**AN ANALYSIS OF THE RESULTS OF NHTSA TESTS
USING THE TWG RECOMMENDED PROCEDURES
FOR EVALUATING OCCUPANT INJURY RISK FROM
DEPLOYING SIDE AIRBAGS**

Prepared
by the
Comparison of Procedures Subcommittee
of the
Side Airbag Out-of-Position Injury Technical Working Group

February 6, 2003

Figure 1. Results reported by the NHTSA for Tests A01_08 and A01_34.

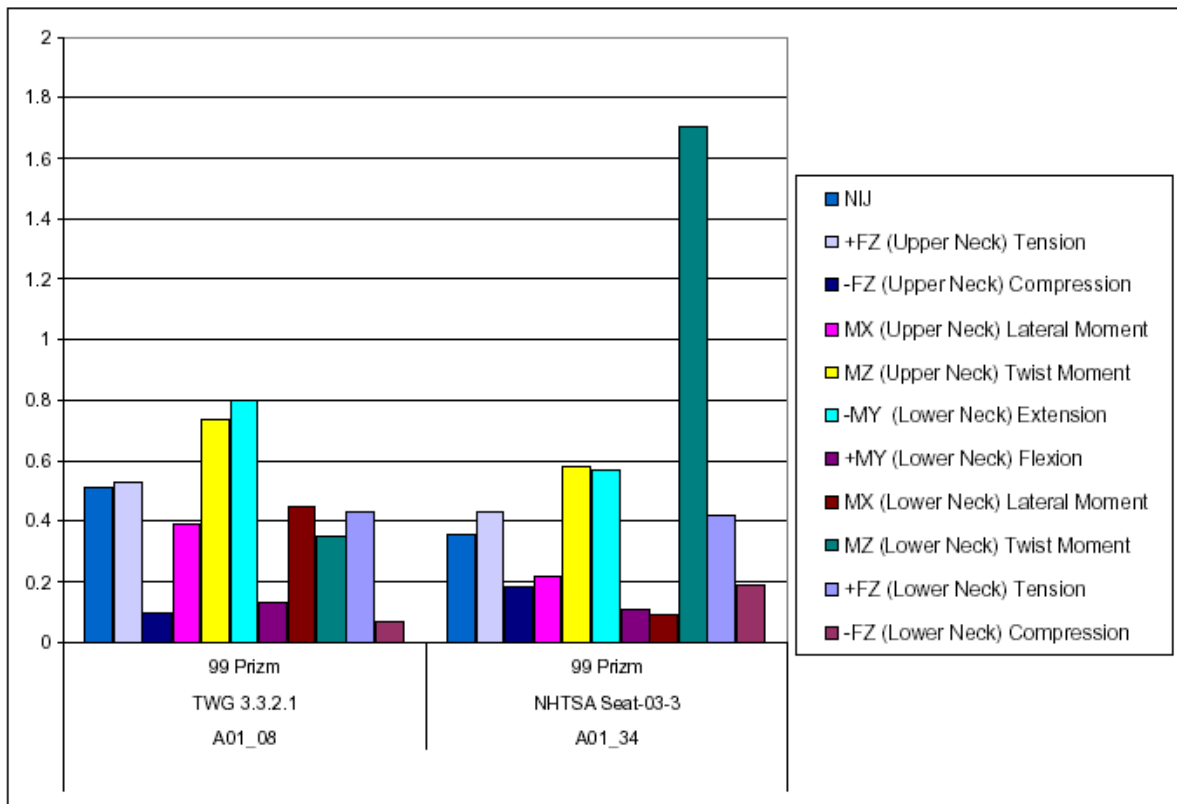
Figure 1 shows the neck load results of the Chevy/Geo Prizm in TWG Position 3.3.2.1 (Test A01_08) and NHTSA Position Seat 03-3 (Test A01_34) as reported by the NHTSA. The data show that the lower neck twist moment was exceeded by a result that was 1.7 times the limit value. This was the only value in any of the Prizm tests that exceeded the limit value. In fact, this data point appeared to stand alone in the bar graphs of the results. Given this interesting finding, the time-history data provided by the NHTSA (Figure 2) was examined. Based on that data, the peak lower neck twist moment was approximately 10 Nm, as shown in Figure 2. The limit value of 17 Nm had, in reality, not been exceeded.

The source of this error is not known to the CoPS (transcription, typographical, etc), but the time-history data are the primary source of all resulting injury indices and are presumably the most accurate. **Thus, contrary to the conclusion in the NHTSA report, the NHTSA revised position in the Chevy/Geo Prizm did not identify any significant additional OOP injury risk compared with the baseline TWG Position.**

Figure 3. Results reported by the NHTSA for Tests A01_73, A01_178, A01_152 and A01_153.

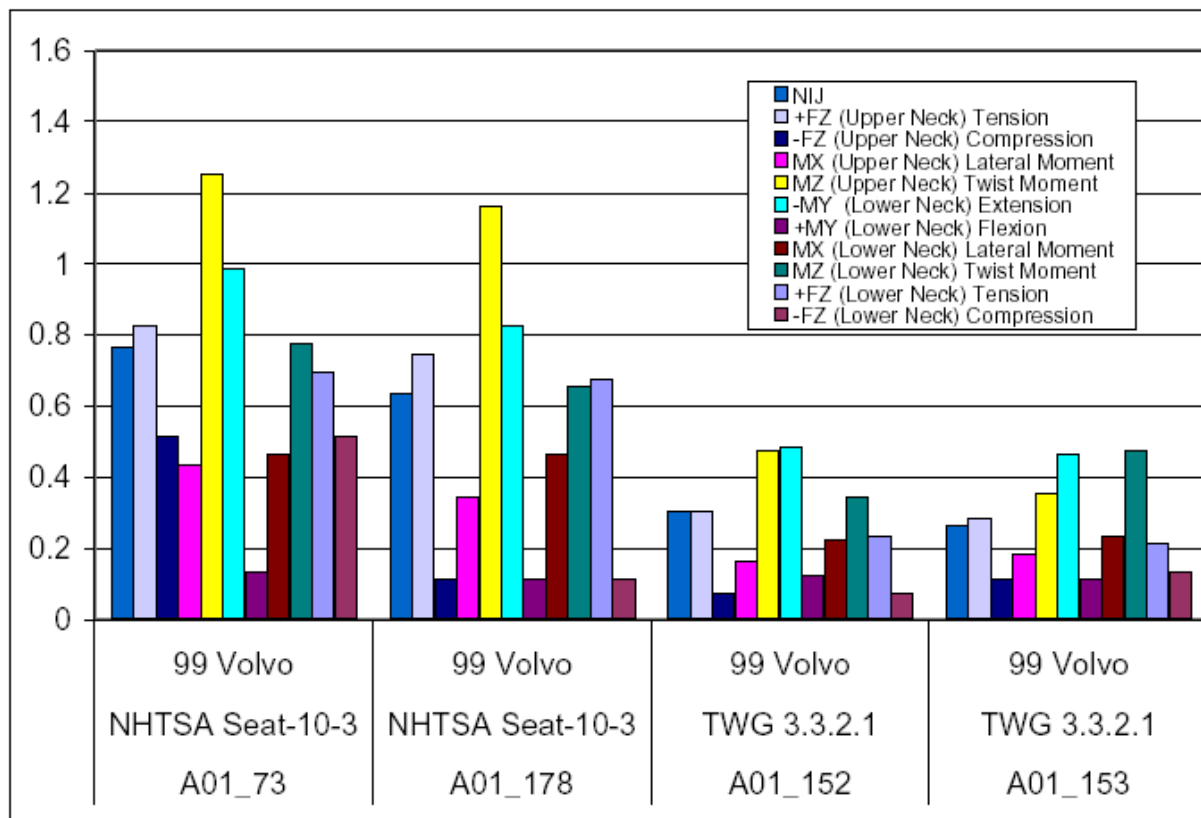
Figure 3 shows the neck load results of the Volvo S-80 in TWG Position 3.3.2.1 (Tests A01_152 and A01_153) and in NHTSA Position Seat 10-3 (Tests A01_73 and A01_178). In both tests with the NHTSA positions, the upper neck twist moment research value was exceeded. In addition, the lower neck extension moment was close to the research value in Test 73. The data were not close to any of the reference or research values in either test with the TWG positions. This difference led us to dig deeper into the data and to request the time-history data and high-speed video data from these tests. This was provided by the NHTSA on their website and also by CD-ROM.

From a review of the photographic documentation of the NHTSA's evaluation of TWG Position 3.3.2.1, it appears that the dummy was not positioned as specified for TWG position 3.3.2.1. Figure 4 shows the test setups for the tests A01_152 and A01_153 (NHTSA's TWG tests). Several important observations can be made when reviewing these photographs. First, TWG Position 3.3.2.1 instructions call for the laboratory to setup the test such that:

Neither of these conditions was met in the NHTSA tests (see photographs of dummy position for Tests A01_152 and A01_153).

In short, the NHTSA tests did not accurately reflect the TWG position by not bringing the torso or pelvis into contact with the door and by not placing the arm on the armrest. Much of this was noted in details of the NHTSA report. However, **since the TWG Procedures were not carried out as intended, the conclusion that the NHTSA Positions were more discriminating may not be accurate.**
